Office Action Summary

10/564,226

THOEMMES, FRANZ

DETAILED ACTION

Examines Marked up Figure 4

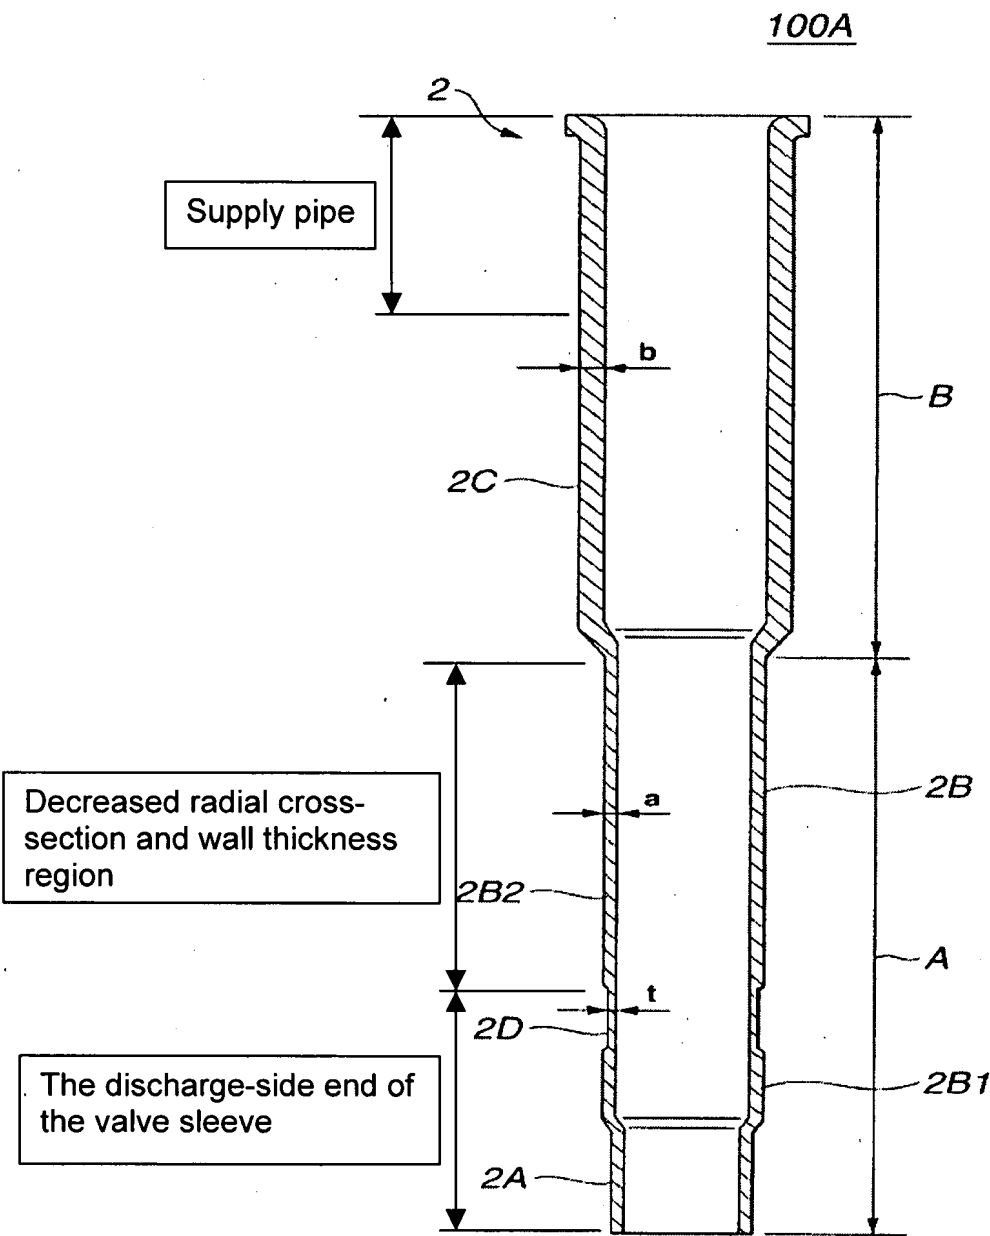
Kobayashi et al shows a fuel injector (1) comprising; a valve needle (7a) an armature (7c) forming an axially movable valve port together with the valve needle, a restoring spring (9) acting upon the armature, a magnetic coil (11) cooperating with the armature, a valve-seat body (5b), a valve closure member (7b) which forms a sealing seat with the valve seat body and; a valve sleeve (2) surrounding the armature and the valve needle, a wall thickness of the valve sleeve varying across its axial direction (fig 4), wherein the wall the wall thickness of the valve sleeve decreases in a discharge

direction of a fuel (figure 4), wherein a radial cross section of the valve sleeve decreases between an inflow-side region and a discharge-side region on a color (figure 4), wherein the radial cross section and the wall thickness of the inflow-side region are constant from the collar to an inflow-side end of the valve sleeve (figure 4); wherein the decreased radial cross section and decreased wall thickness of the discharge-side region are constant from the collar to a discharge-side end of the valve sleeve (see examiners marked up figure of figure 4), and wherein the inflow side region of the valve sleeve is formed in one piece with a supply pipe (see examiners marked up figure 4).

Regarding claim 10, the thickness of the valve sleeve is about .3 to .6 mm in an inflow-side region (paragraph 0038).

Regarding claim 14, the thickness of the valve sleeve is about .2 to .5 mm in a discharge-side region (paragraph 0035).

Secondly, since applicant does not define where "a discharge-side end of the valve sleeve," is located, the examiner is considering the discharge-side end of the valve sleeve to be everything including and below the reduced thickness section 2D of the valve sleeve shown in figure 4. Therefore, the valve sleeve has a constant wall thickness and cross-sectional area from the collar to the discharge-side end of the valve sleeve.
